# Stage 04: Code Administrator Consultation

# GC0099:

## Modification Title: Establishing a common approach to interconnector scheduling consistent with the single intraday market coupling processes set out within Regulation (EU) 2015/1222 (CACM).

Figure 1

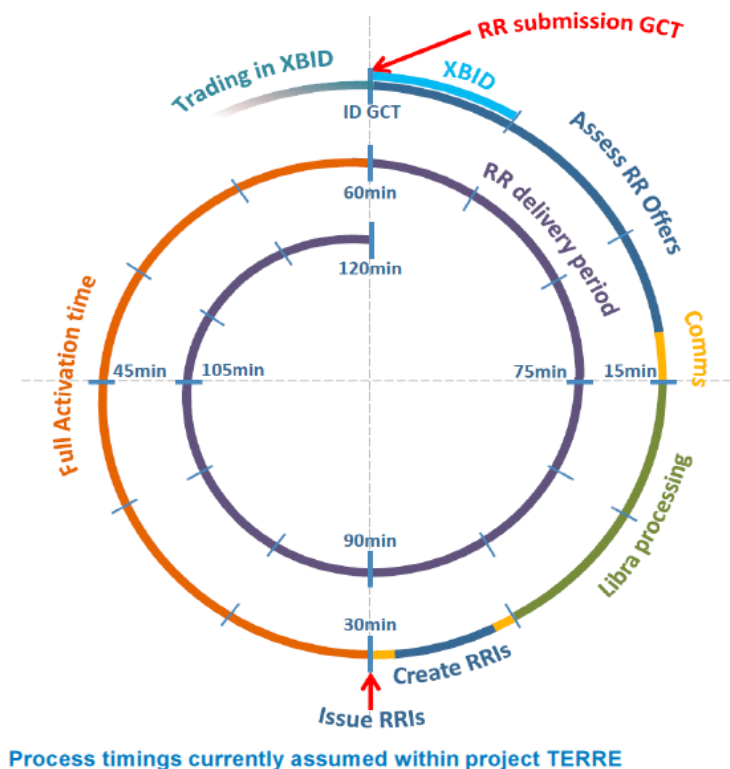
The spiral diagram in figure 1 was talked through; the timings for which reflect the current proposal for the ongoing Modification Project TERRE. The timings being proposed have not all been finalised, however the deadline for receipt of information by the central platform (15 mins after gate closure), full activation time (30 minutes) and the delivery period (60 minutes) have been long established<sup>1</sup> within the TERRE project and National Grid understands that changing these times would represent a significant risk to the successful delivery of the project.
